Determination 2015/003

Compliance of a retaining wall between two properties at 34A and 36B Ballin Street, Ellerslie, Auckland

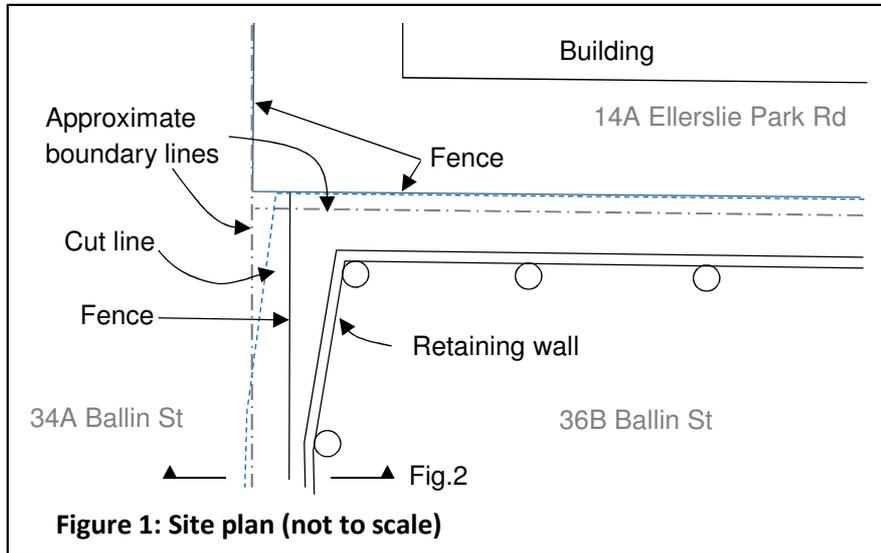
- 2.2 The site at 36B was excavated to the approximate cut line shown in Figure 1 above. The retaining wall is constructed approximately 350mm inside the boundary of 36B to an estimated height of 1100mm, with the ground behind the retaining wall backfilled to the height of the retaining wall.
- 2.3 The fence between 36B and 34A has been constructed approximately 100mm out from the retaining wall.
- 2.4 The difference in height between the ground level in 34A and the top of the retaining wall is up to 500mm and was left as an open cut face – refer figure 2 below “as-built”.

- The consent drawings indicate the top of the retaining wall (RL 46.65m) as being 1150mm above the proposed floor level (RL 45.50m).
- Allowing 200mm from the proposed floor level to the finished ground level, and assuming level ground between the dwelling and the retaining wall, this would indicate the retained height was more likely to be 1.35m not 1.1m.
- The retaining wall design and drawing covers retained heights up to 2.0m; the expert had no concerns regarding the design and calculations.
- The drawing depicts a barrier attached to the top of the wall and indicates essentially level ground behind the wall (refer Figure 2); boundaries are not indicated on the retaining wall design drawings.

5.3 During the site visit the expert located a boundary peg and noted that the excavation had been taken right up to the boundary but appeared not to have been cut in a straight line. The fence was constructed approximately 100mm from the retaining wall, and the difference in level between the actual ground level in 34A and the top of the retaining wall was up to 500mm and left as an open cut face. The cut face would be concealed by the fence when looking from 36B.

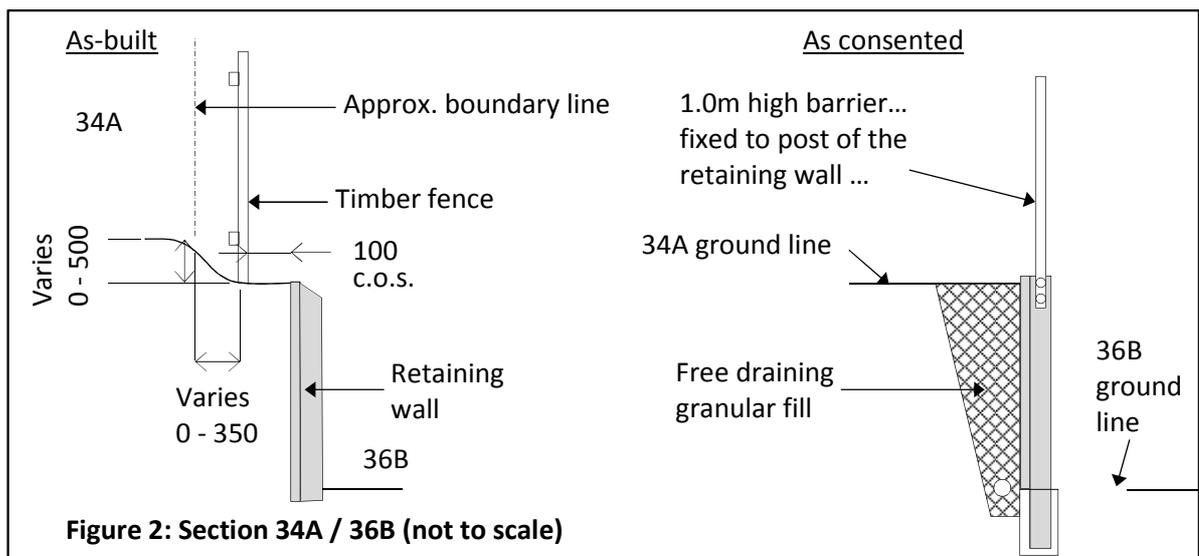
- 2.1 The building work consists of a timber retaining wall constructed on or near the boundary between 36B Ballin Street (“36B”) and the adjacent properties at 34A Ballin Street (“34A”) and 14A Ellerslie Park Road (“14A”) – refer Figure 1 below.
